## ARCHITECTURAL REVIEW BOARD STAFF REPORT

<b>Project #/Name</b>	<b>ARB-2021-08: Pantops Holiday Inn Express and Suites Minor</b>
<b>Review Type</b>	Minor Amendment
<b>Parcel Identification</b>	07800-00-00-058G1
<b>Location</b>	870 Pantops Corner Way
<b>Zoned</b>	Highway Commercial (HC) / Entrance Corridor (EC)
<b>Owner/Applicant</b>	Pantops Partners, LLC / J.W. Enochs Inc., General Contractor (J. Wilson Enochs III)
<b>Magisterial District</b>	Rivanna
<b>Proposal</b>	To relocate mechanical equipment and add screening; to revise site lights and to add feature lighting; to remove the sun-shade.
<b>Context</b>	The hotel is part of the Pantops Corner development, which includes a Wawa convenience store and gas station (both under construction) and a self-storage building.
<b>Visibility</b>	The hotel rises above the nearby buildings and is visible from distances on Rt. 20 and Rt. 250. Topography and other construction limit some views of lower portions of the building.

<b>ARB Meeting Date</b>	March 1, 2021
<b>Staff Contact</b>	Margaret Maliszewski

Figure 1a: Approved west elevation with sun-shade.

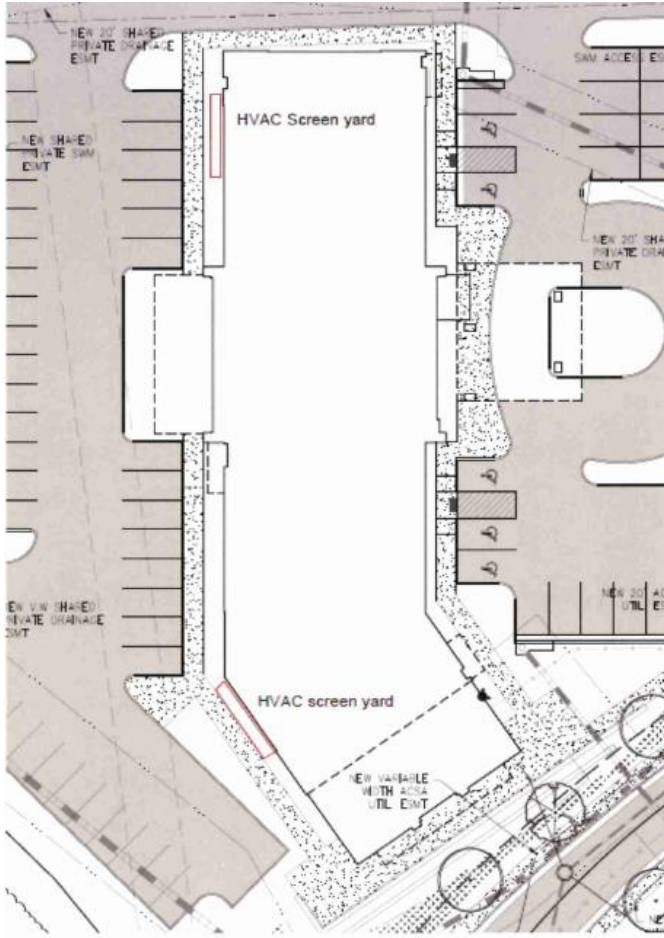
this tradition are contained in Appendix A.		
4	The examples contained in Appendix A should be used as a guide for building design: the standard of compatibility with the area's historic structures is not intended to impose a rigid design solution for new development. Replication of the design of the important historic sites in the area is neither intended nor desired. The Guideline's standard of compatibility can be met through building scale, materials, and forms which may be embodied in architecture which is contemporary as well as traditional. The Guidelines allow individuality in design to accommodate varying tastes as well as special functional requirements.		
	<b><i>Compatibility with the character of the Entrance Corridor</i></b>		
5	It is also an important objective of the Guidelines to establish a pattern of compatible architectural characteristics throughout the Entrance Corridor in order to achieve unity and coherence. Building designs should demonstrate sensitivity to other nearby structures within the Entrance Corridor. Where a designated corridor is substantially developed, these Guidelines require striking a careful balance between harmonizing new development with the existing character of the corridor and achieving compatibility with the significant historic sites in the area.	The sun-shade on the west elevation provided a visual connection to the Rt. 250-facing elevation. Without the sun-shade, the building appears less cohesive.	See recommendations, below.

<b>SPECIFIC GUIDELINES</b>		
	<b><i>Compatibility with significant historic sites</i></b>		
	<b>Structure design</b>		
9	Building forms and features, including roofs, windows, doors, materials, colors and textures should be compatible with the forms and features of the significant historic buildings in the area, exemplified by (but not limited to) the buildings described in Appendix A [of the design guidelines]. The standard of compatibility can be met through scale, materials, and forms which may be embodied in architecture which is contemporary as well as traditional. The replication of important historic sites in Albemarle County is not the objective of these guidelines.	The sun-shade on the west elevation helped to break up the building mass, it added an element of human scale, and it established a tie to the front elevation. Without it, the elevation appears more blank and less finished. Alternate features or detailing could substitute for the sun-shade and establish a cohesive overall design; for example, individual canopies over the ground story windows in a material/color consistent with the front canopy. (See Figures 1a – 1c.)	Provide alternate architectural elements to substitute for the sun-shade on the west elevation.

1. Provide alternate architectural elements to substitute for the sun-shade on the west elevation.
2. Indicate on the plan the equipment height, the screen height and a screen color that blends with the building.
